# 45 McLaren St

## North Sydney

Response to Council RFI

February 2024

**Pictured**  
Corner of McLaren & Walker Street

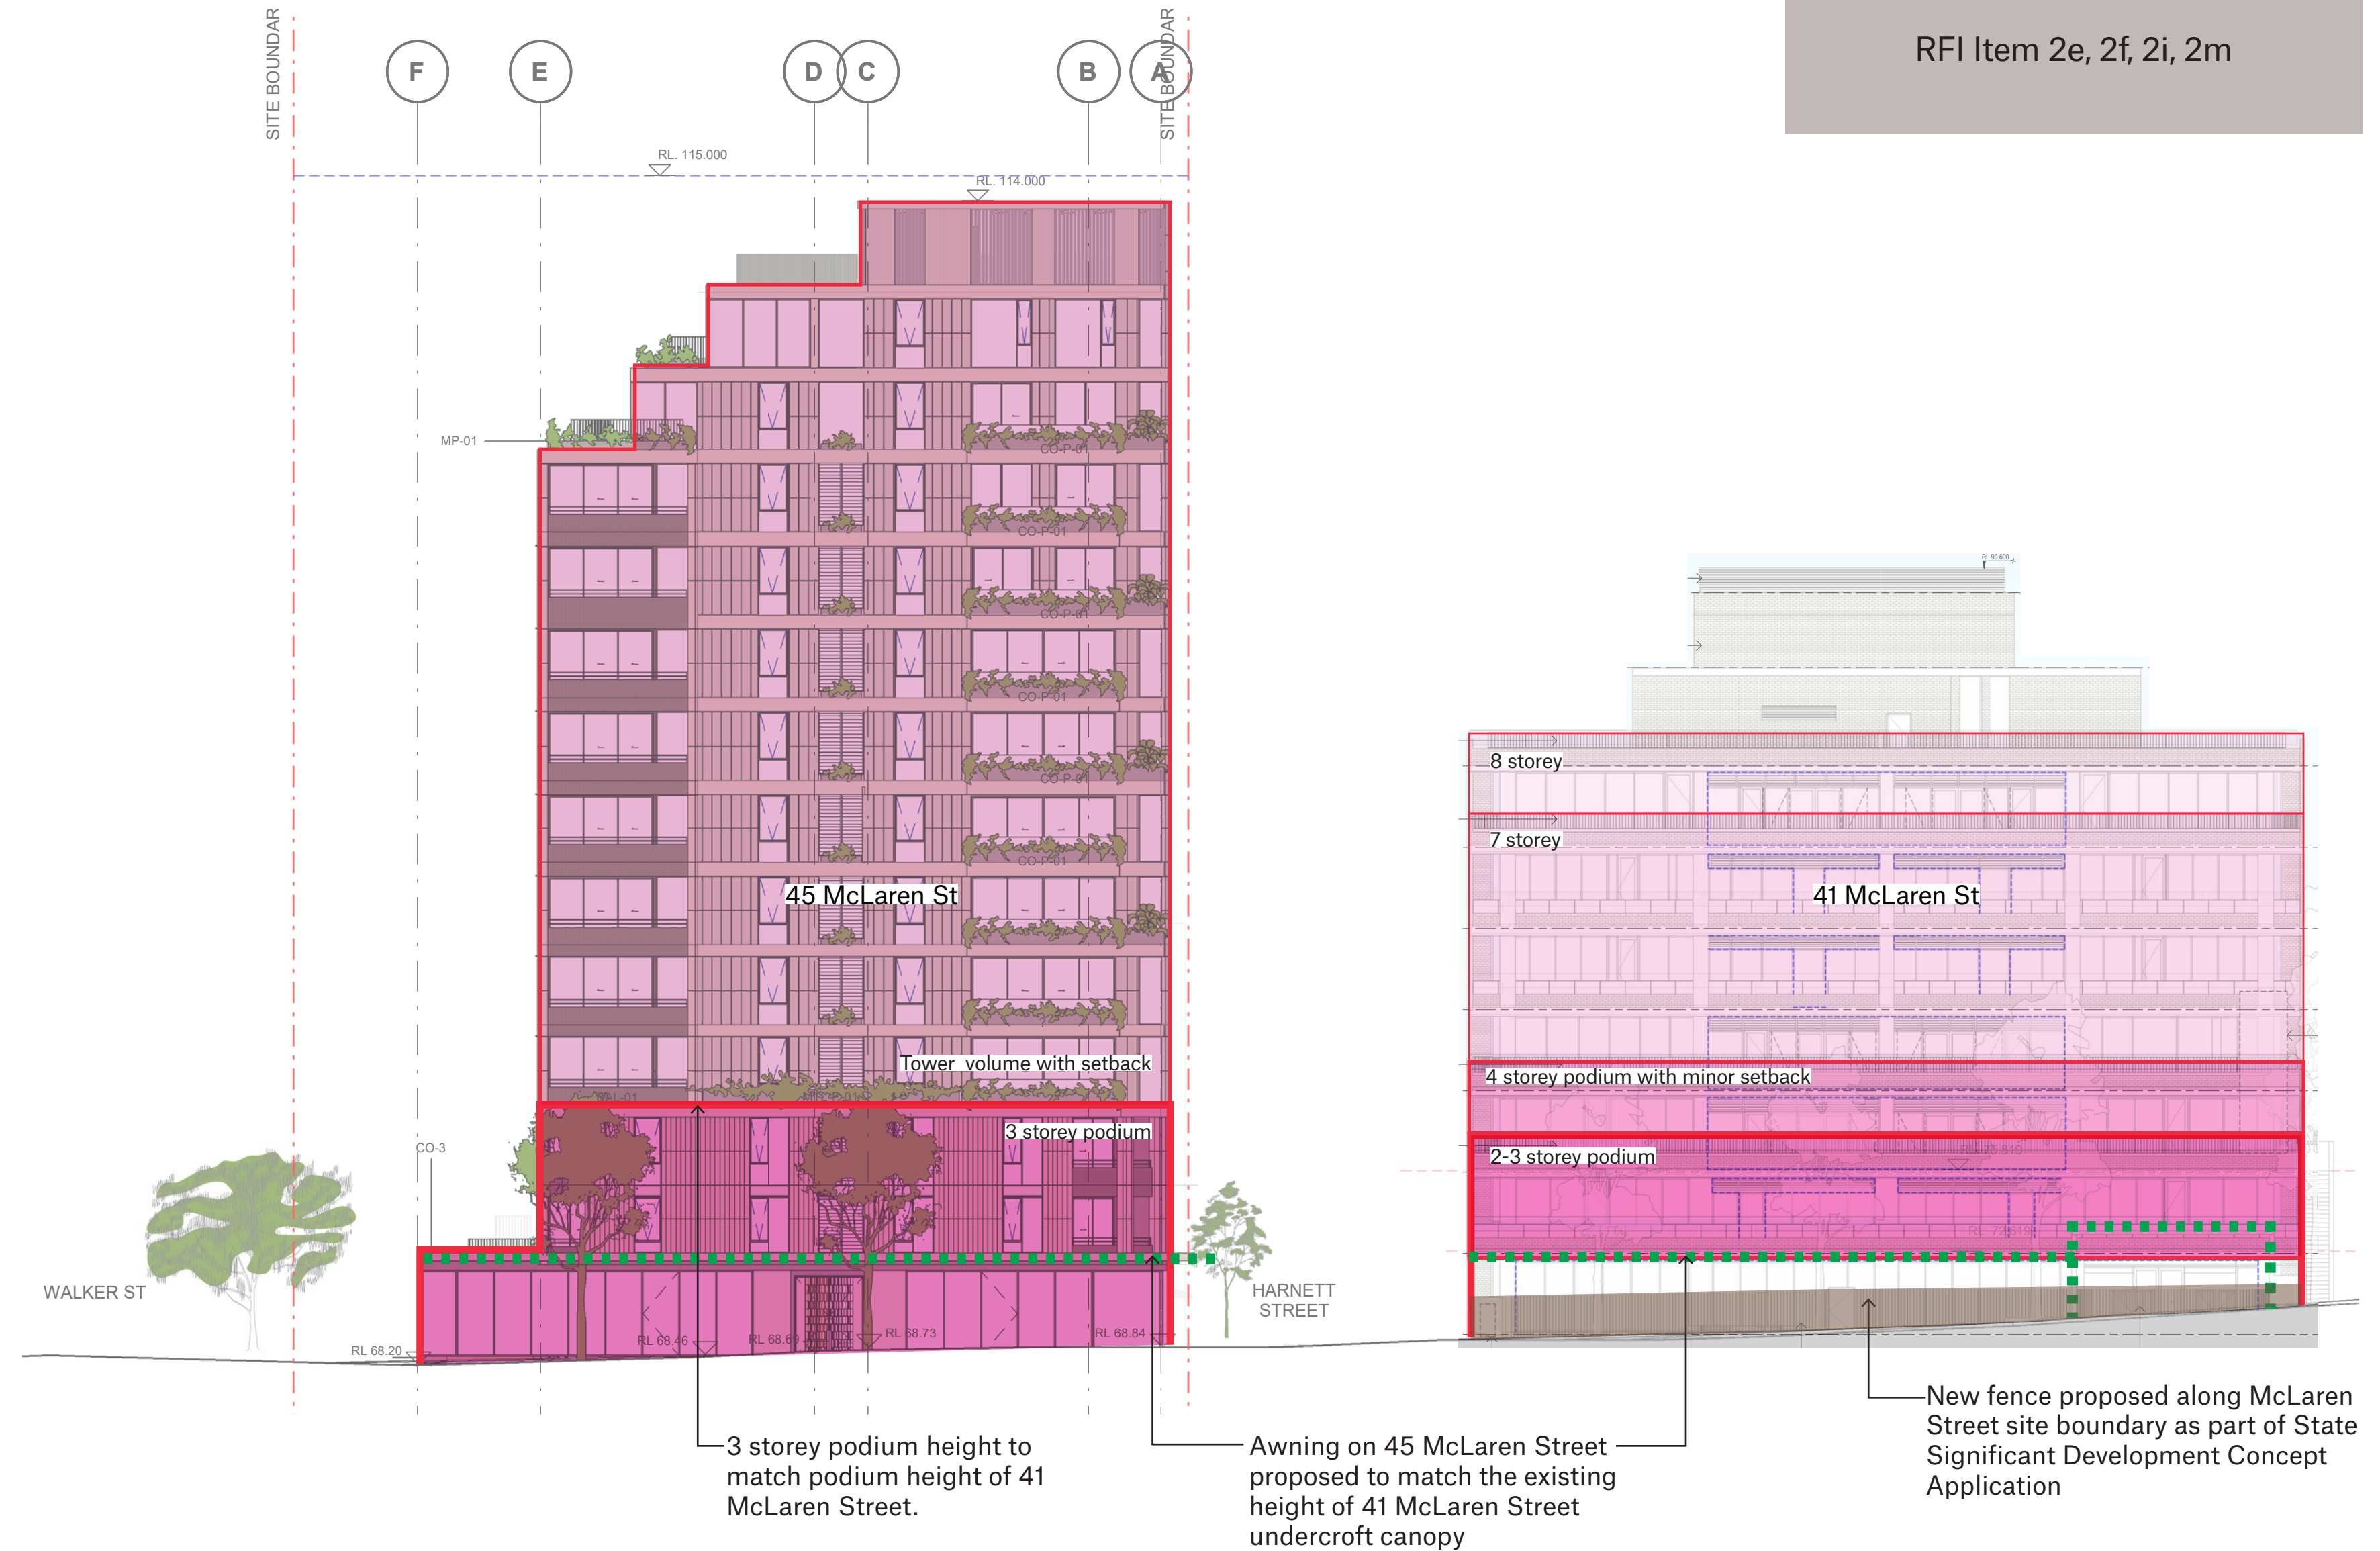
***Podium setbacks*** to Walker Street and more generally the design of the ***south-eastern corner of the building*** do not appear to ***relate appropriately*** to the adjacent heritage buildings.

The Northeastern corner of the proposal has been specifically designed to respond to the changing context between McLaren and Walker Street. This is achieved through a thoughtful combination of scale variation and the incorporation of concrete frames and awnings.

To ensure a harmonious relationship with neighbouring homes along Walker Street, the terrace homes feature concrete frames that create a 2-storey scale. Additionally, the main tower is intentionally set back generously, preserving a 2-storey podium to maintain the lower-scale residential character along Walker Street.

At the intersection of Walker and McLaren Streets, the 2-storey height is reduced to a single storey due to the site's slope. This reduction in height also suggests a shift in use from residential to retail/commercial tenancy, comparable to the mixed residential, commercial, and hotel character of McLaren Street.

The concrete frames typically used in terrace homes are transformed into a continuous awning that wraps around the corner, providing cover along McLaren Street. This awning promotes the activated street frontage on McLaren Street with a 3-storey podium, maintaining consistent scale of the street wall with the podium of heritage building at 41 McLaren Street.

**Pictured**  
Planters along Walker Street with adjusted sandstone walls and planting

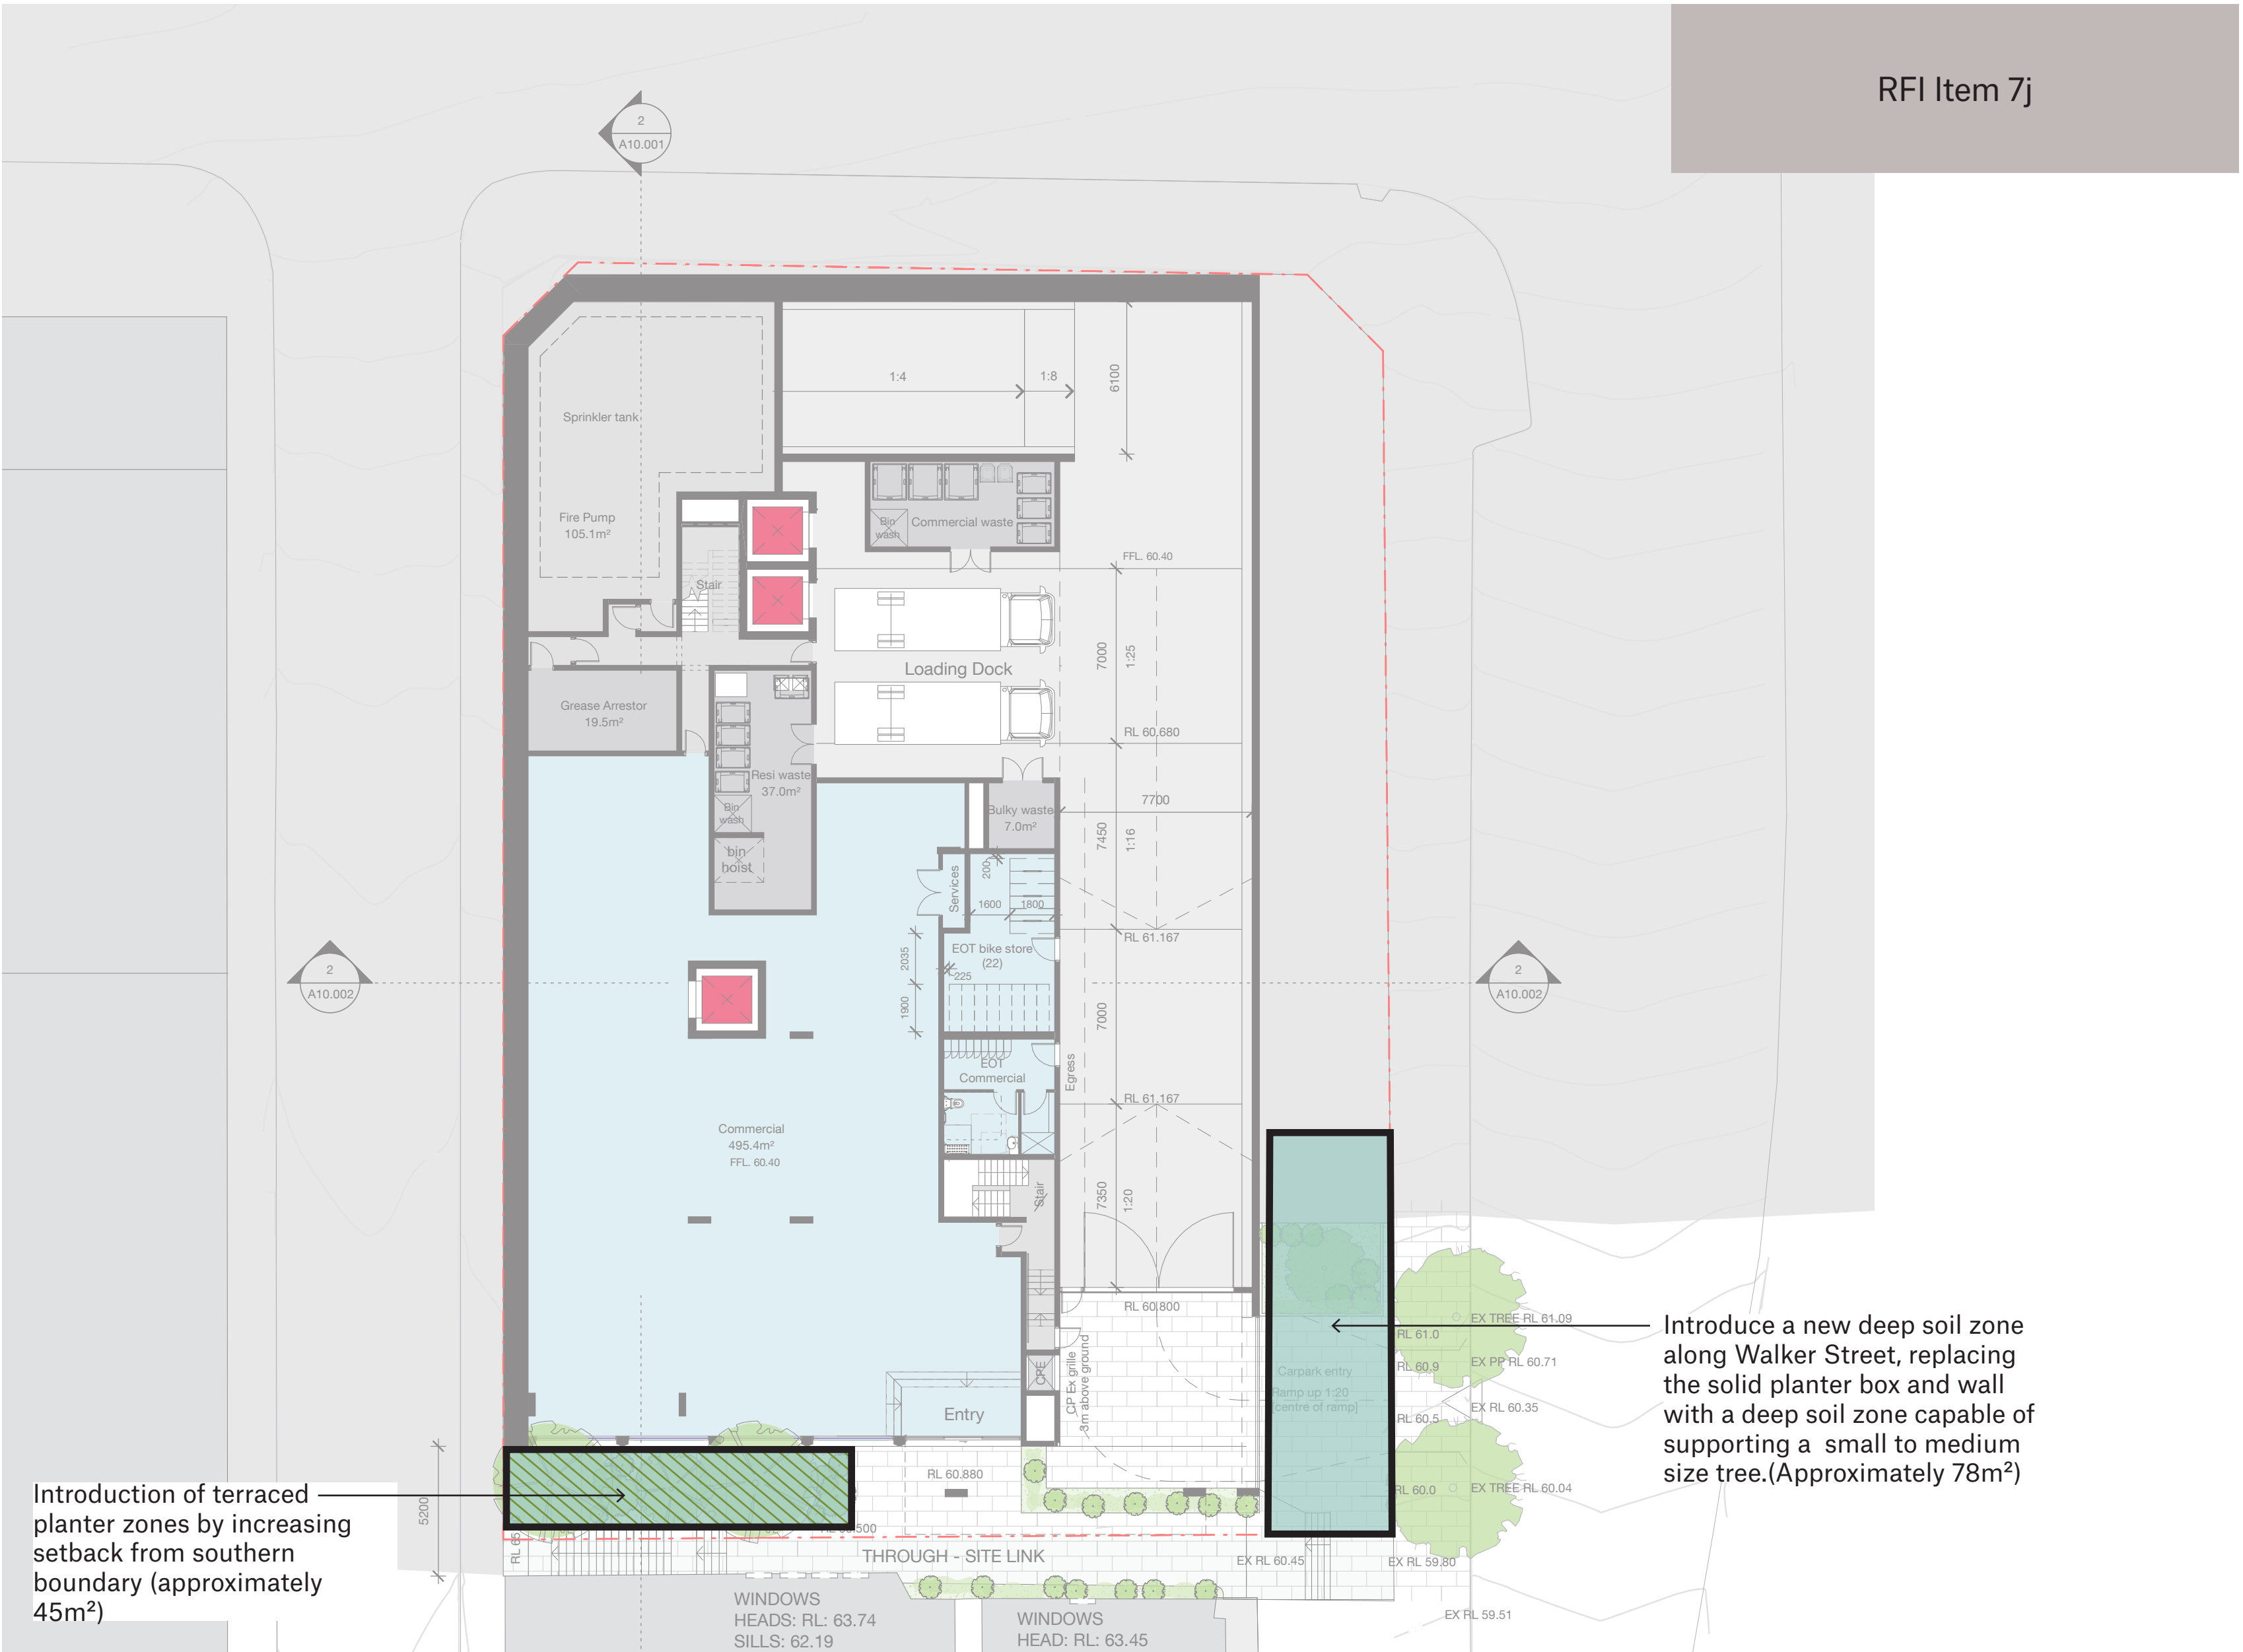
*Landscaping in public domain to improve the **softening of the building** at its edge to Walker Street.*

Terracing of sandstone planters are adjusted to lower height. Also, cascading plants will be allowed to planters to minimise visible hard surface such as sandstone to visually soften the building at its edge.
